ADDENDUM #3

Magnolia Lane (#3124A) Drainage Improvements
Project No. 2017-02
Bid No. 17-0806

JOB NO.:
STR16001
SHEET:
C-7

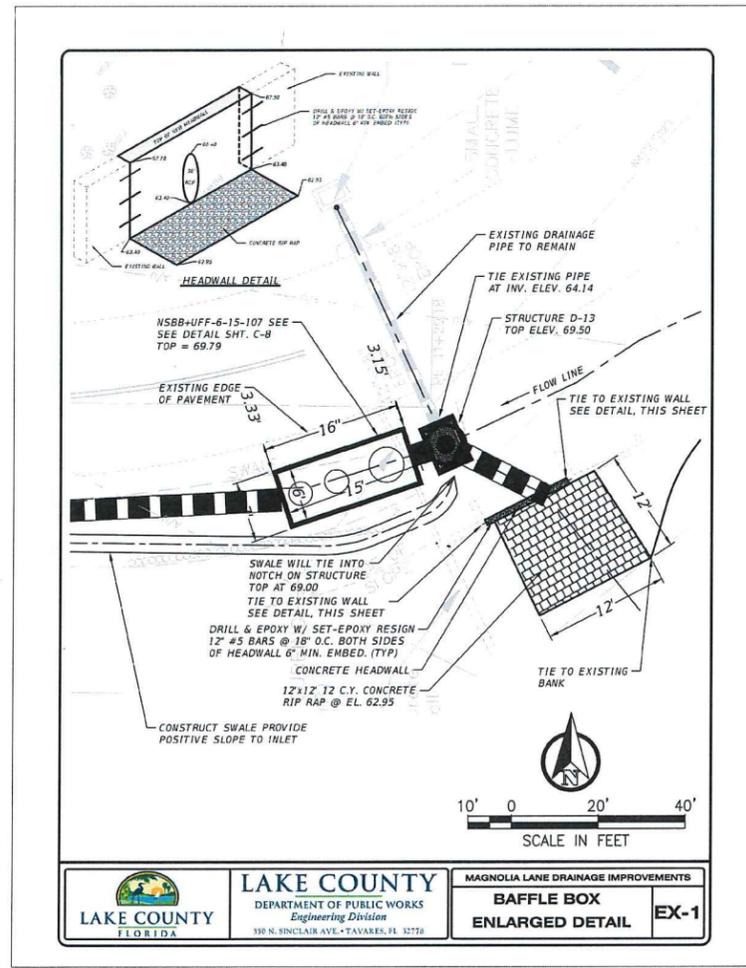
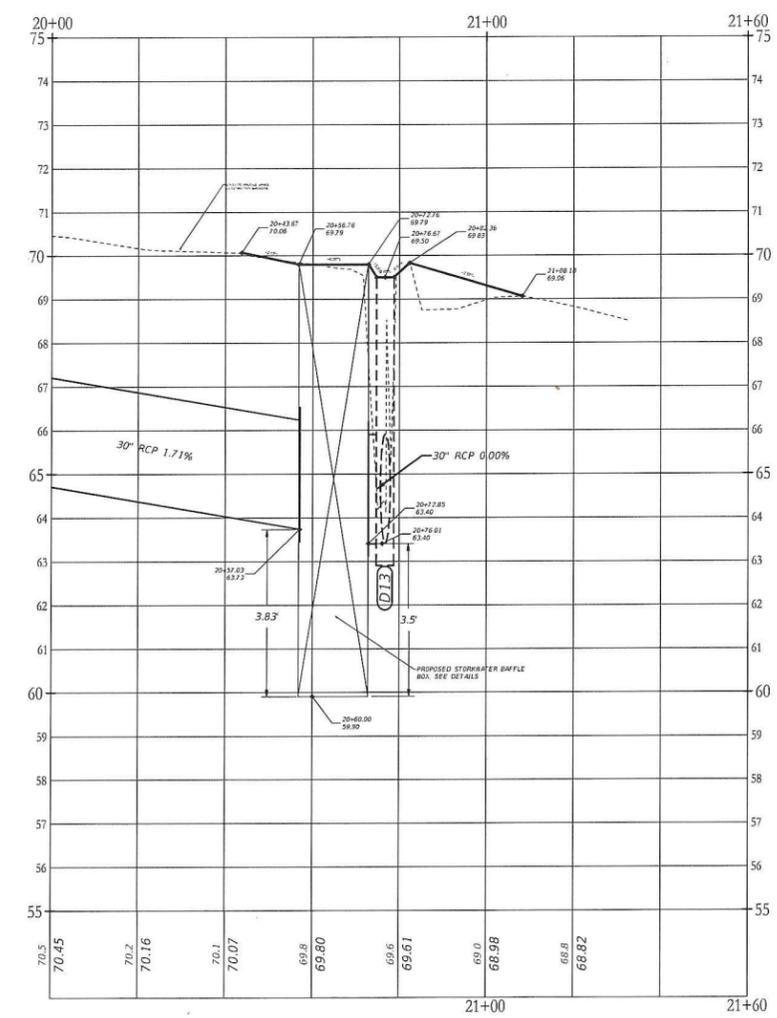
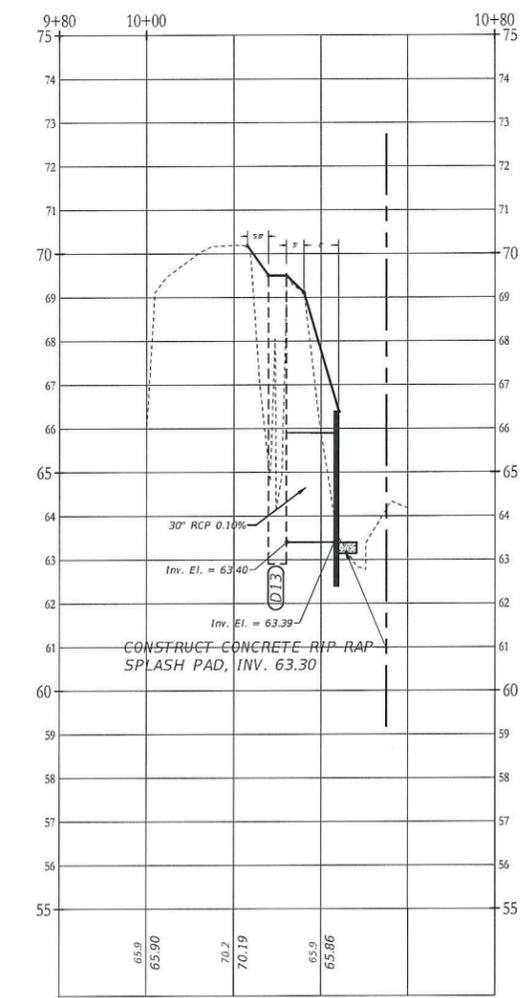
Q8: Plan Sheet C-7 Baffle Box and outfall plan – can a larger plan or a cleaner plan be provided, there are a lot of printed details making it difficult to read and distinguish the necessary information?

A8: Lake County is providing updated plan sheets C-7 & C-8 with Addendum #3. Please see included sheets C-7 & C-8 for reference.
